ADDENDUM No. 5

Date: November 26, 2019
To: All Bidders
From: **Jenkins•Peer Architects**
Charlotte, N.C.
Re: UNC Charlotte – Residence Hall Phase XVI
SCO ID: 18-18333-02A
JPA Project #: 18NCC016

2 PARTIAL LEVEL 1 TELECOMMUNICATIONS PLAN - IDF 135
1/2" = 1'-0"

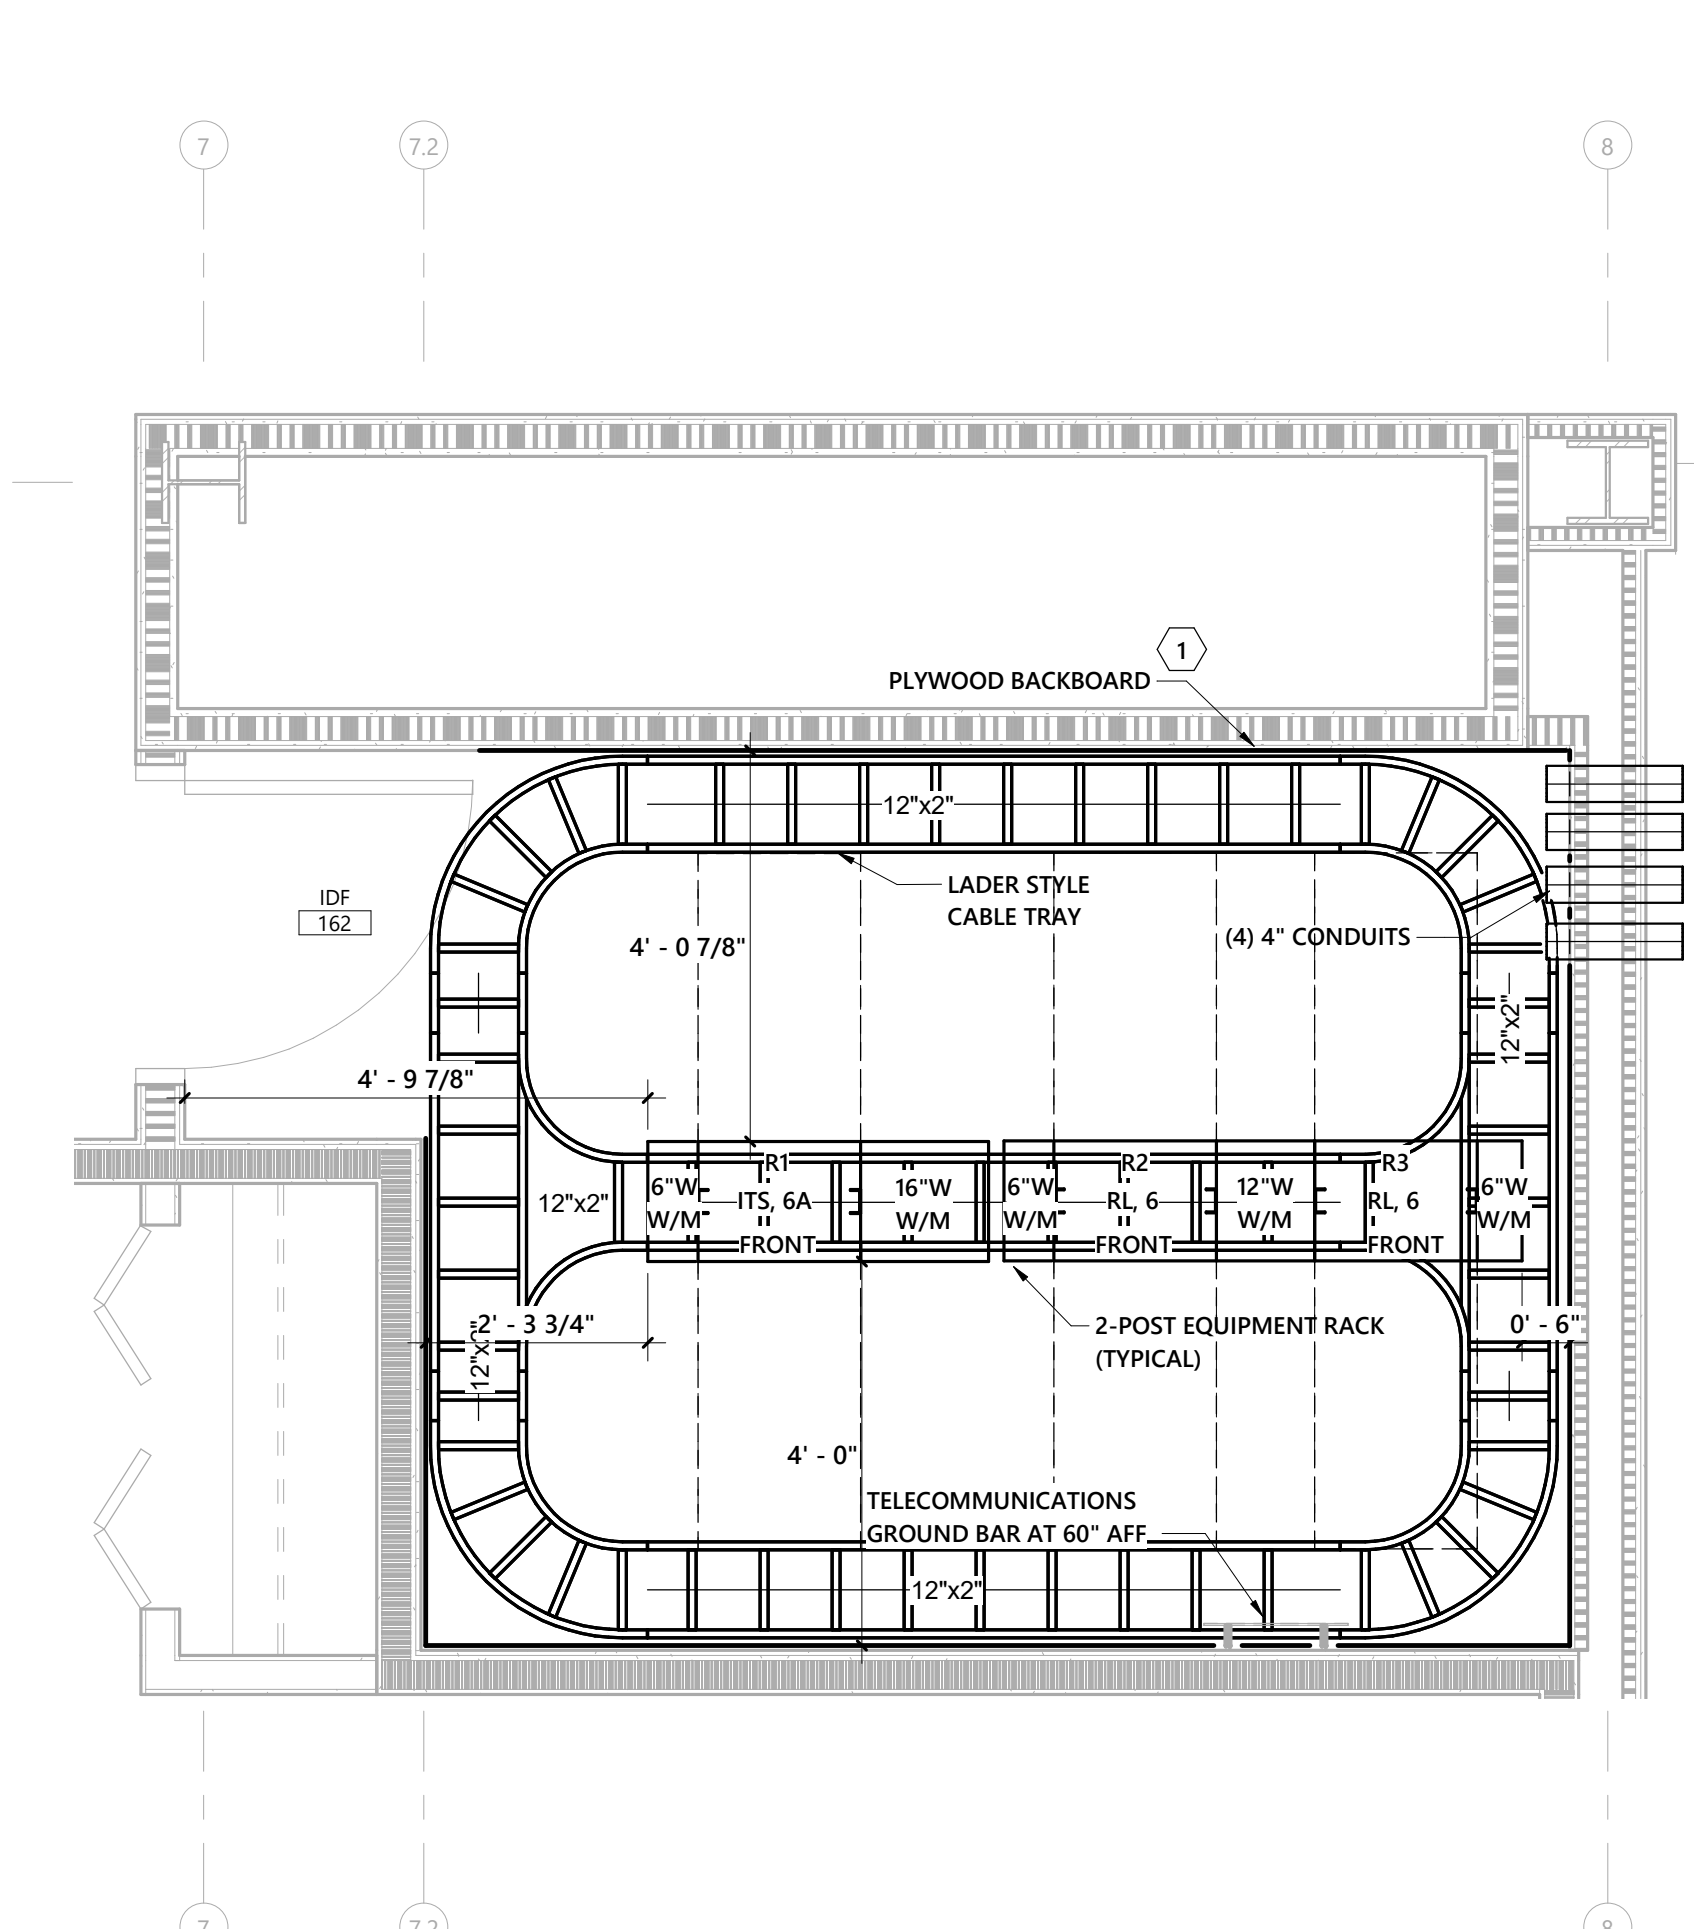
QUESTION: The legend (drawing TC-000) has two different types of WAP symbols. One type gets 2 CAT 6 cables. The second type with the subscript ITS gets 2 Cat 6A cables. The rack elevations only shows patch panels space for CAT6A WAP (yellow) cables. Do all WAPs get 2 CAT 6A cables or is there a mixture of CAT 6 and CAT 6A WAP outlets and the rack elevations need to have a CAT 6 panel for CAT 6 WAP cables?

QUESTION: Drawing TC-501 (rack elevations) does not show which rack the backbone fiber or the 25 pair copper should terminate in. Also what size fiber enclosure is required?

RESPONSE: There are two different types of WAPs with different cabling requirements. ITS cabling shall be terminated on ITS patch panel and Resident Life shall be terminated on RL patch panels in associated racks. Rack elevations will be updated for clarity.

RESPONSE: Terminate fiber optic cable in RL rack and 25 pair copper on patch panel in IDFs. Provide a 2RU enclosure for fiber connectivity. Rack elevations will be updated for clarity.

TELECOMMUNICATIONS
 DETAILS

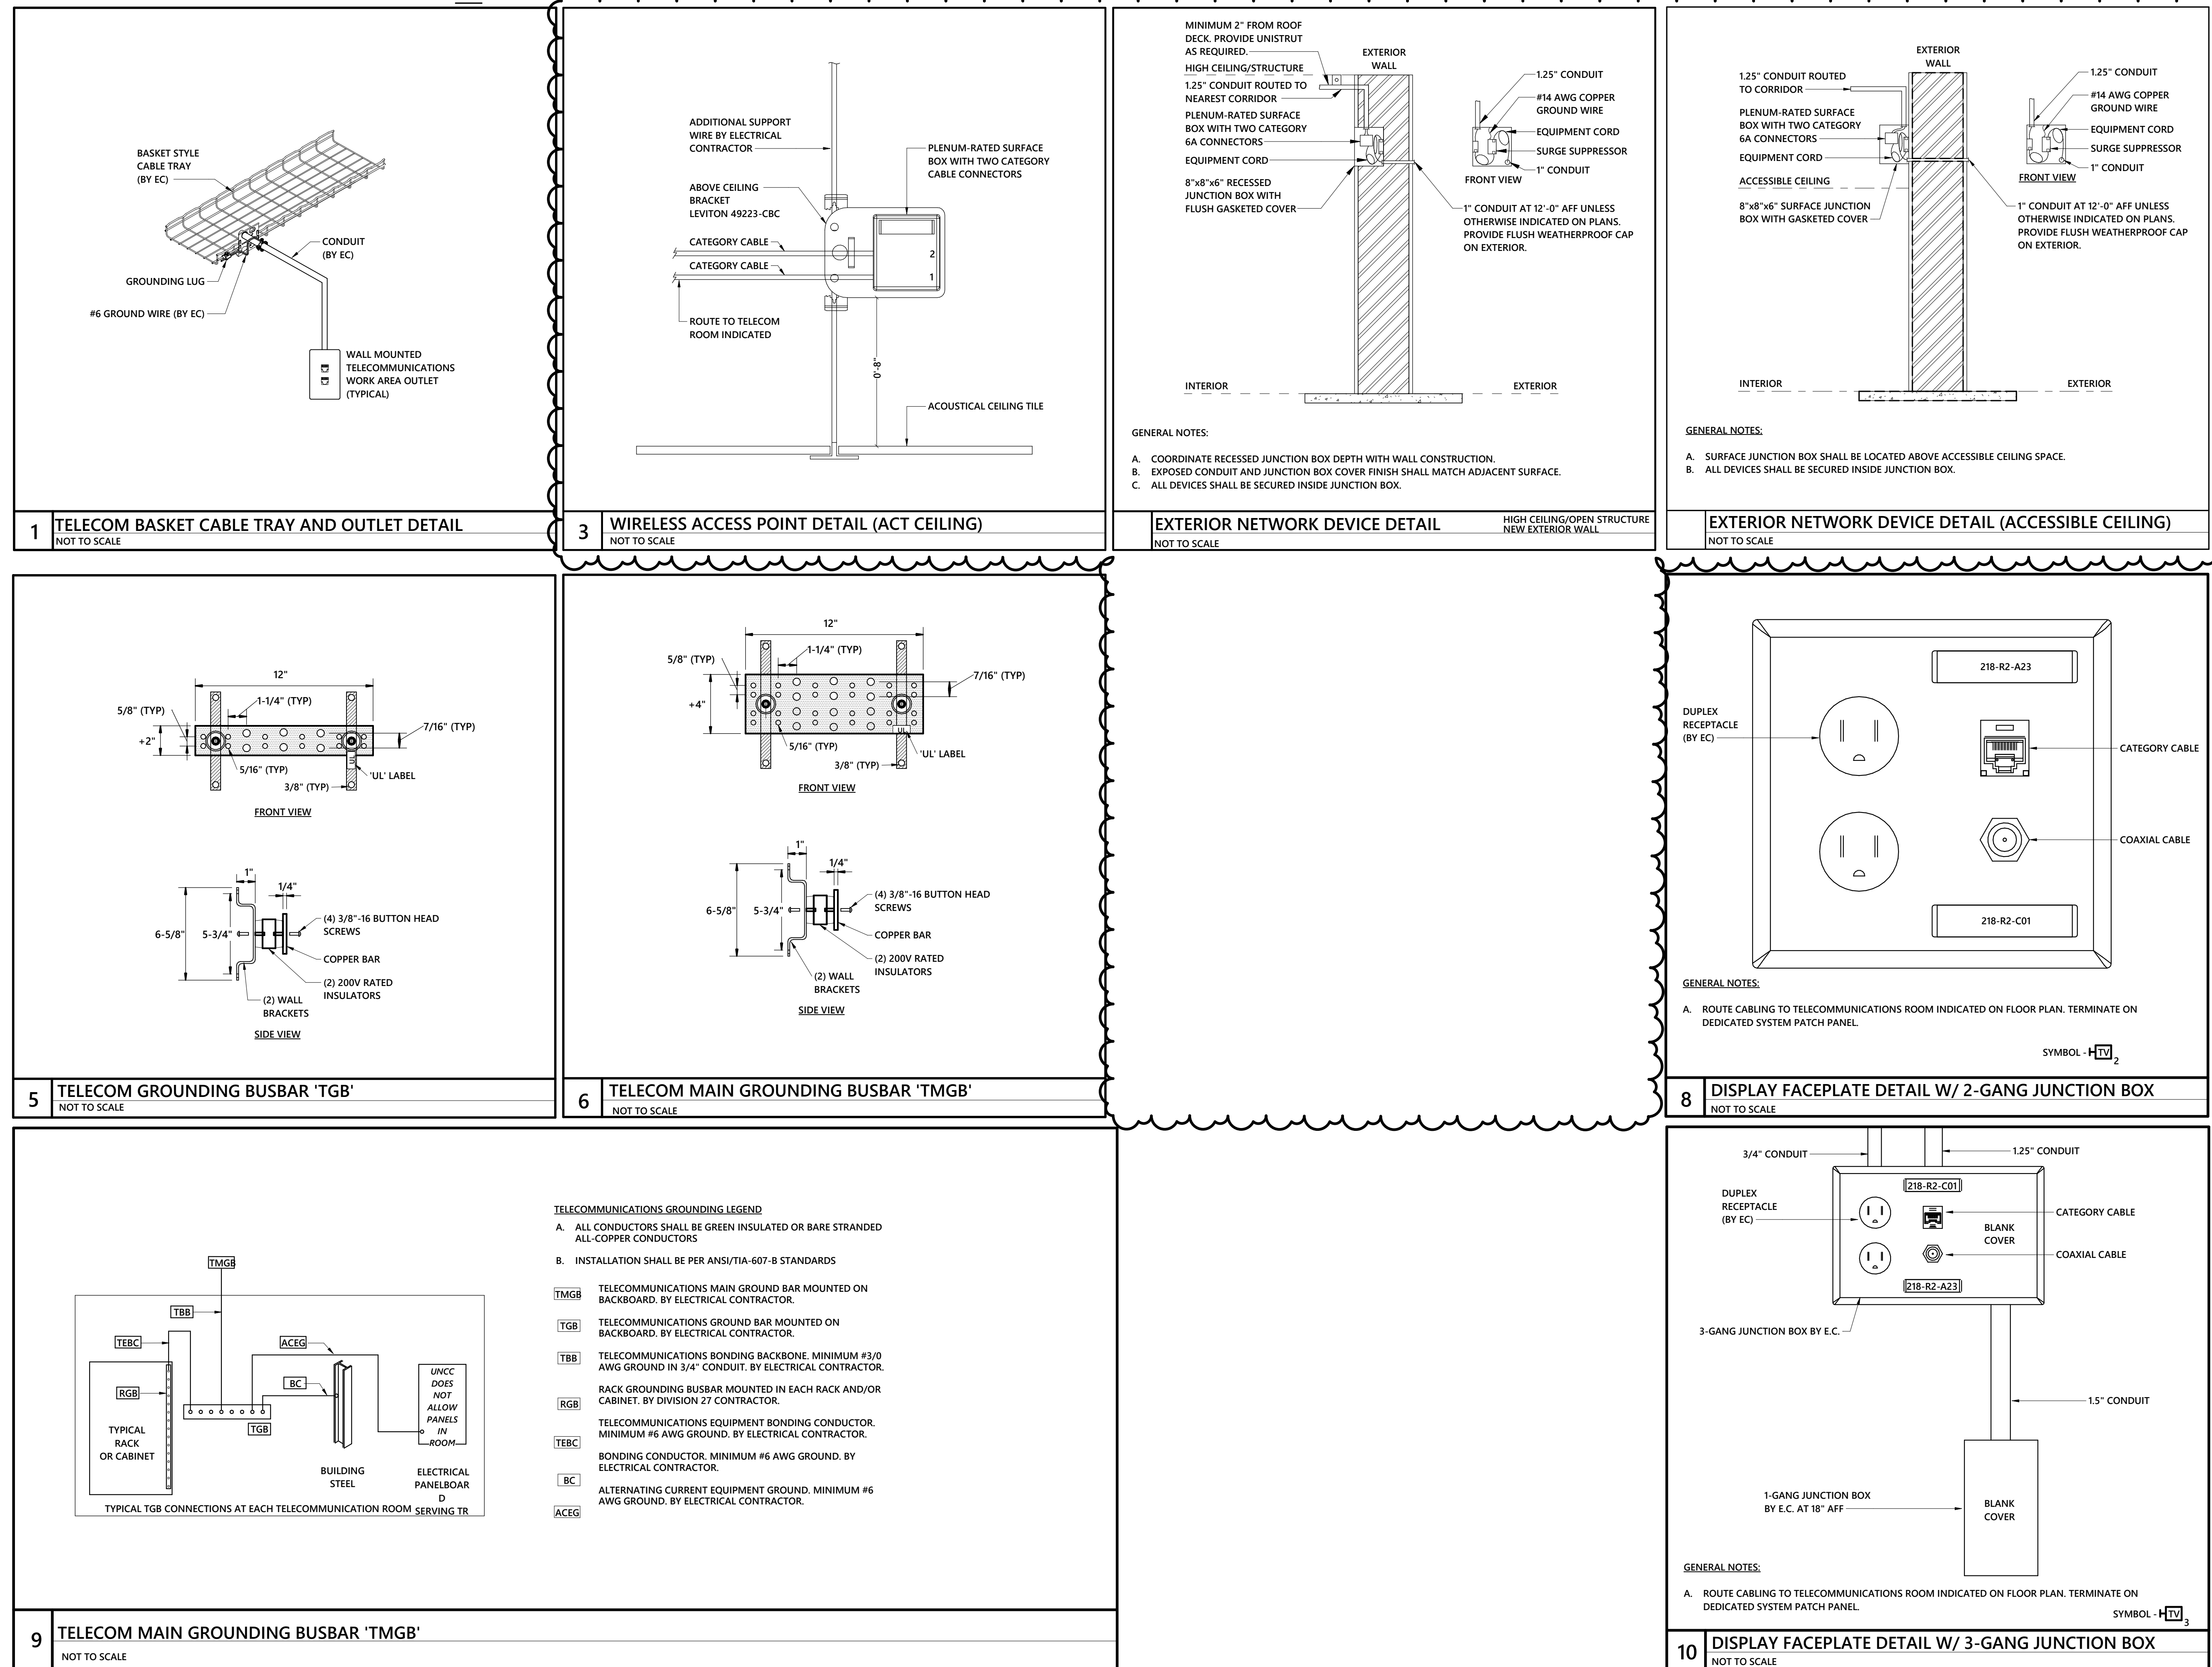
QUESTION: Drawing TC-601 figure 4 shows a single gang faceplate for typical telephone data device 2 port. The specs refer to double gang faceplates for all hardwall devices and the symbol legend says single gang mud ring. Which is correct?

RESPONSE: There are two different types of data drops with different cabling and junction box Requirements. Open triangle (ITS) has a larger double gang box with a double gang trim ring while the Filled triangle (RL) has a standard double gang box with single gang trim ring.

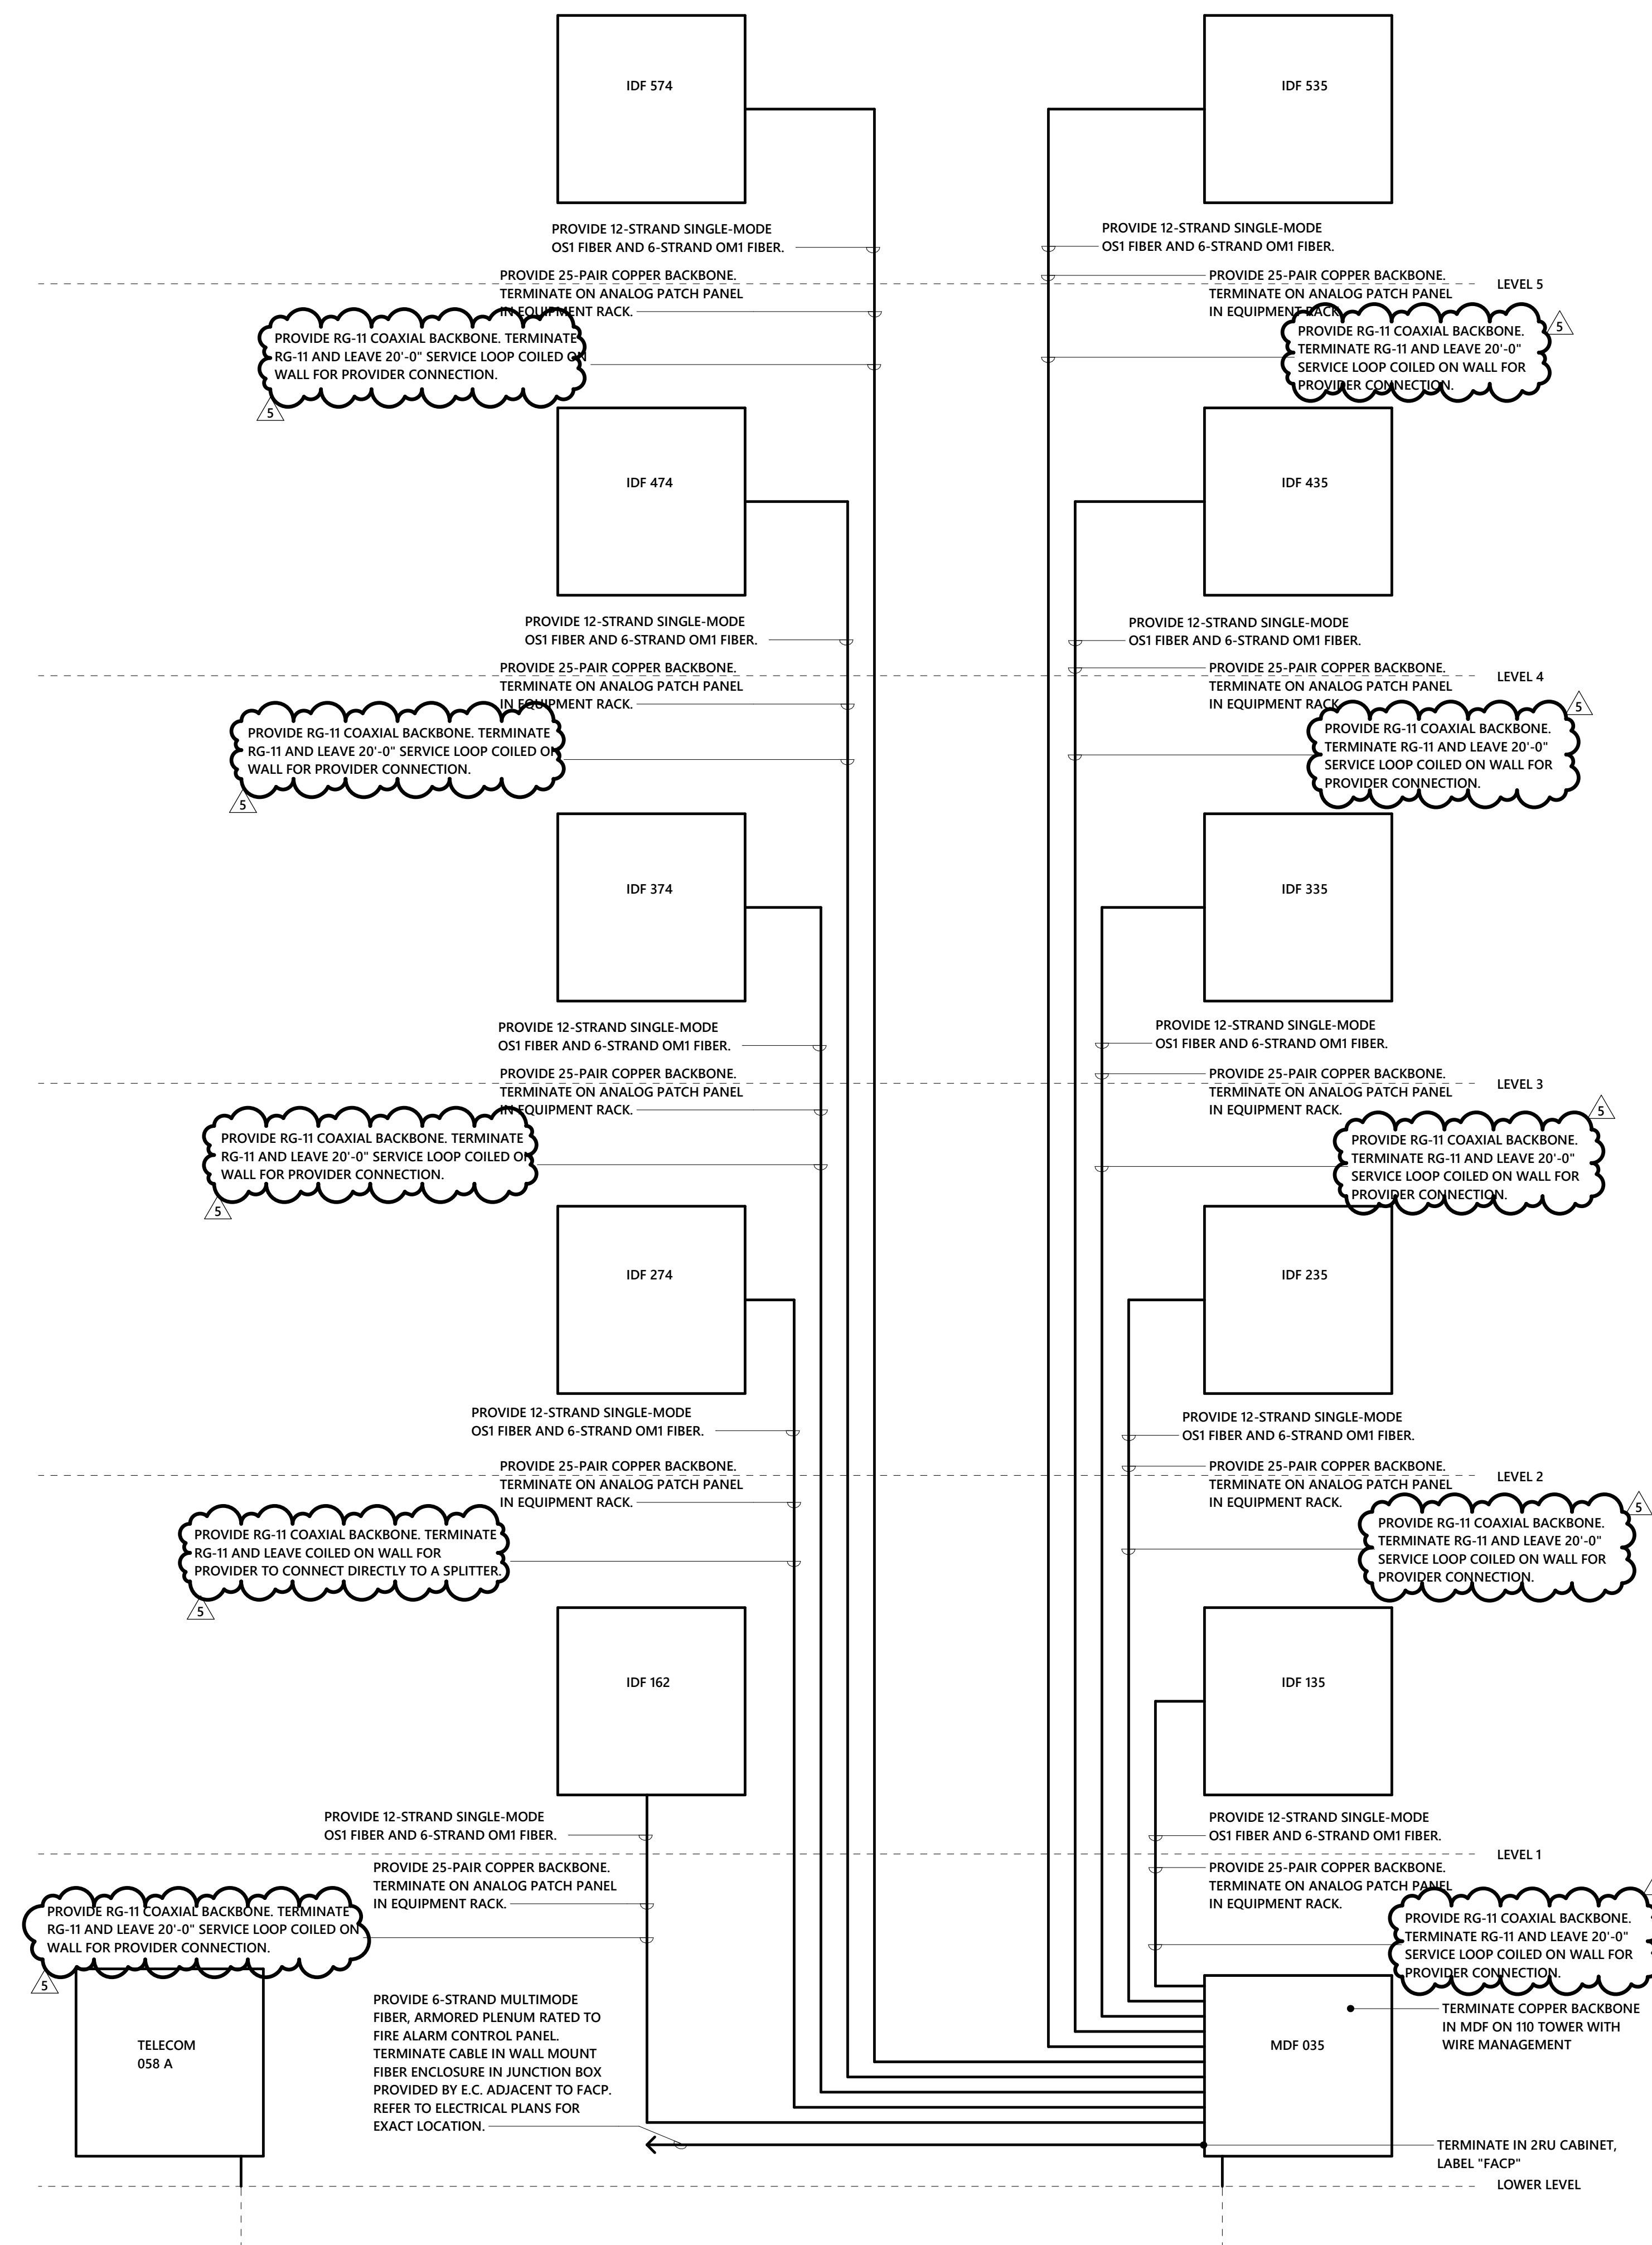
QUESTION: The telecom distribution diagram drawing TC-701 indicates that the 6 strand multi-mode fiber is OM1 (62.5/125). Should we be using 50/125 OM3 armored plenum fiber?

QUESTION: The telecom distribution diagram drawing TC-701 indicates the RG-11 terminate on a wall mounted patch panel. Is this correct? Typically, the RG-11 is terminate and left coiled on the wall ready for the provider to connect it directly to a splitter. Do the RG-6 to the TV outlets terminate in the racks or should they be left coiled on the same wall as the RG-11?

RESPONSE: Revise OM1 fiber on distribution diagram is correct per UNC Charlotte manual

RESPONSE: Correct. Drawing will be revised. Terminate RG-11 and leave coiled with service loop on the wall ready for the provider to connect it directly to a splitter. RG-6 to the TV outlets should they be left coiled with service loop on the same wall as the RG-11.
